**RE: Ghost River Gravel Pit, File No. # M-2024-029, New 112c Application,  
Adequacy Review-1**

The Division of Reclamation, Mining and Safety (Division/DRMS) is in the process of reviewing the above referenced application to ensure that it adequately satisfies the requirements of the Colorado Mined Land Reclamation Act (§ § 34-32.5-101-34-32.5-125) (Act) and the associated Rules and Regulations for the Extraction of Construction Materials (Rules). During review of the material submitted, the Division determined that the following issues of concern shall be adequately addressed before the application can be considered for approval.

### **Exhibit D – Mining Plan**

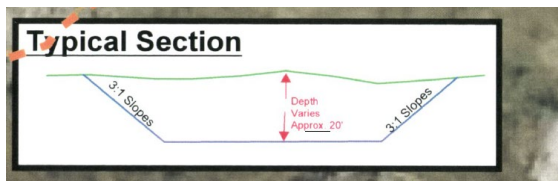
6. Rule 6.4.4(a) requires the Applicant to provide a “description of the method(s) of mining to be employed in each stage of the operation as related to any surface disturbance on affected lands”. On the Exhibit D – Mining Plan Map, the Applicant provides a “Typical Section” view of the site (see images below). The cross section depicts the sides of the pit being sloped at a 3H:1V, up to the permit boundary. Additionally, a note on the map states that “All slopes shall be mined to a 3:1 or flatter, except for the working face”.

- Please clarify whether the Applicant intends for all the highwalls to be within the pit, and away from the perimeter of the affected area against the permit boundary. This meaning that no highwalls would occur along the permit boundary to ensure that all side slopes are not mined at a slope angle greater than 3H:1V.

7. On the Exhibit D – Mining Plan Map, the Applicant provides a “Typical Section” view of the site (see images above), that states that the depth of the pit varies and is approximately 20 feet.
- Please clarify whether 20 feet will be the maximum depth of the pit, or if it is the average depth of the pit. If it is the later, please provide a maximum depth measurement.
8. Rule 6.4.4(d) requires the Applicant to provide the “the size of area(s) to be worked at any one time”.
- Pursuant to Rules 6.4.4(d-e), please provide an estimate of the amount of time required to mine each Phase of the operation.
9. The Applicant states that the operation will likely take between 3-5 years, total.

12. Pursuant to Rule 6.4.4(g), please state whether there will be any secondary commodities to be mined at this site.
13. Within the Mining Plan, the Applicant states that all interior haul roads will be temporary and will be reclaimed after mining has been completed. On the Mining Plan Map, the haul road is shown extending from the entrance of the mine to the northeast corner. On the cross section (see image pasted with Item #6 above), it indicates that there will be a 3H:1V slope along the east side.

- Please clarify whether the road will be sloped at a 3H:1V, or if the cross section is incorrect? If it is the latter, please provide an updated cross-section.
